SUBJECT: INSPECTION REPORT NO. 70-1257/2009-202 AND NOTICE OF VIOLATION

Report No.: 70-1257/ 2009-202

Licensee: AREVA NP, Inc.

EXECUTIVE SUMMARY

Figure 1
Six-Pin Connector Configuration

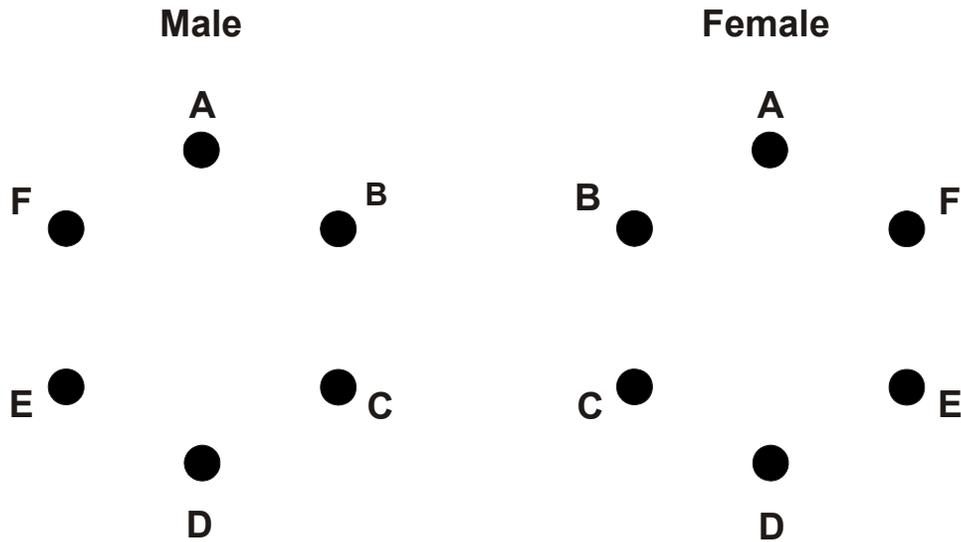
The inspectors reviewed a recent event at the facility which resulted from incorrect wiring of the criticality alarm system detector signal cables. During a recent source check of the criticality alarm system, the licensee discovered that the signal from two of three detectors in one of nine detector locations in the facility were non-functional. The licensee determined that the two malfunctioning detectors were not passing the alarm signal to the comparator for that location. Each detector had two three-wire cables, a power cable and a signal cable. To avoid confusing these cables, the licensee used a three-pin connectors for the power cables and six-pin connectors for the signal cable. The six-pin connector had mirror image male/female ends as shown in **Figure 1**. The licensee set up the six-pin signal cable with three wires and performed a continuity check before placing the cable in operation. The licensee determined that the two malfunctioning cables had been wired incorrectly and the continuity check was also performed incorrectly. As a result of the mis-wiring, the detectors could not pass either an alarm or a fault signal so that the entire three-detector unit was rendered inoperable. The inspectors reviewed criticality accident alarm system placement calculations to determine how coverage of the facility was affected. Final conclusions regarding the event, which was reported to the NRC as EN 45310, will be discussed in a Region II inspection report 70-1257/2009-006.
